MIL-C-172C
Amendment 2
20 OCT 1966

MILITARY SPECIFICATION

Cases; Bases, Mounting; and Mounts, Vibration (For Use with Electronic Equipment in Aircraft)

Figure 6. Automatic Locking Device

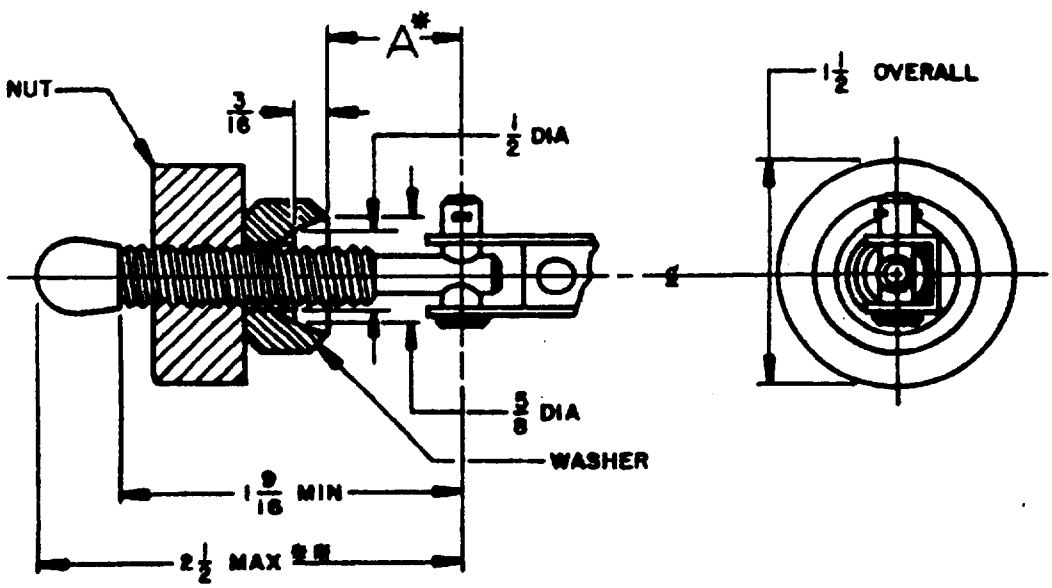
3.5.2.1.2 Automatic locking devices. For all Air Force procurement only automatic locking devices shall be used in all cases, bases, and mounts to prevent loosening thereof under vibration. Dimensions shall be within the envelop shown in figure 6. For Army and Navy procurement suitable automatic locking devices may be used provided they are specified by the procuring activity.

Figure 6: Add new figure 6. Figure 6 forms page 2 of this amendment.

* CLEARANCE ON OPEN OR EXTENDED POSITION 1-3/8 MIN FOR DIM "A"

** THIS DIM SHALL BE NO GREATER THAN NECESSARY TO MEET THE MIN CLEARANCE OF DIM "A"

MATERIAL: CORROSION-RESISTANT STEEL
